**PLANNING COMMISSION SPECIAL MEETING
THURSDAY, SEPTEMBER 23, 2021**

- 4.a (6:20 PM) - Planning Commission Consideration of Public Comments, Deliberation &
Recommendation on Wintergreen Townhomes Subdivision, Site Plan Review and Conditional Use**

Permit Adjustment (PLN51836 SUB SPR CUPA) 2 Hours

Date: August 27, 2021 (*Revised August 31, 2021*)
To: Planning Commission
From: Kelly Tayara, Senior Planner
Project: Wintergreen Townhomes Subdivision
File Number: PLN51836 SUB / SPR / CUPA

Measurements of Natural Areas & Community Spaces (red)
(Source: Preliminary Plat submitted August 27, 2021)

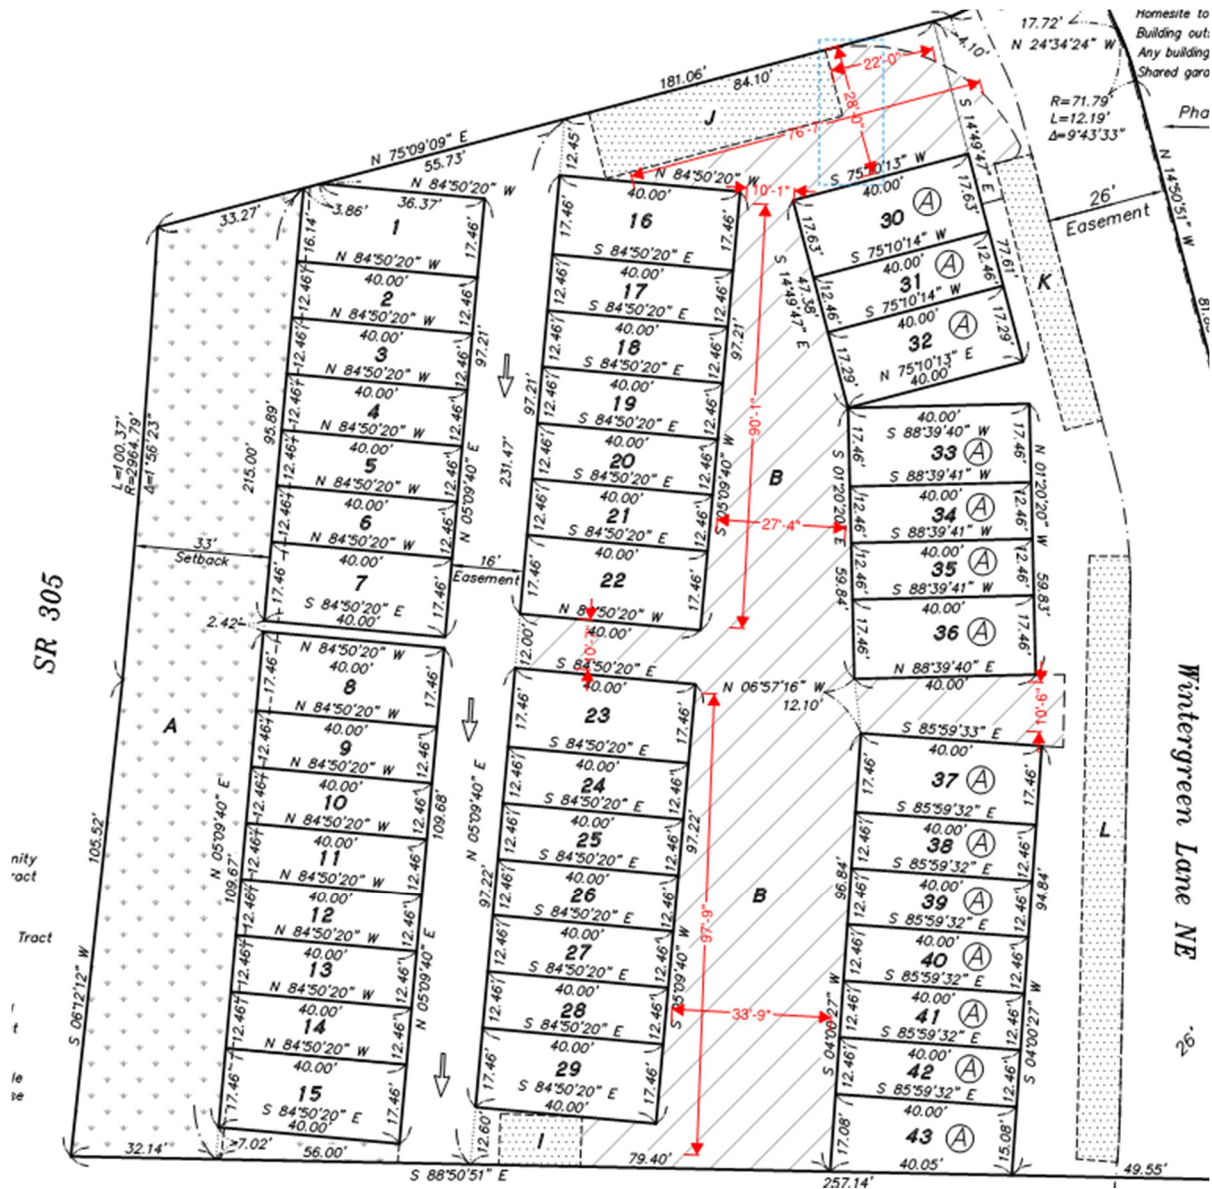
narrative done by Charlie Wenzlau both say that 248 spaces are required for the entire site. Where is Mr. Gori getting 191 from?	The site plan submitted by the applicant for the Wintergreen Townhomes project contains insufficient detail to determine how many parking spaces are provided on each of the properties that make up the Visconsi Master Plan Area (Sheet C4 dated March 16, 2021), nor how many are parking spaces are proposed on the subject properties. The applicant has submitted CC & R's and asserts there are shared parking agreements amongst tenants. Complimentary parking is allowed and encouraged in the Municipal Code, subject to guidelines, except for single family development. The required parking for two or more complementary uses may be reduced up to 50% when provided by a common parking lot, but may not be reduced below the highest parking requirements. A reduction can be authorized as part of a site plan and design review permit.
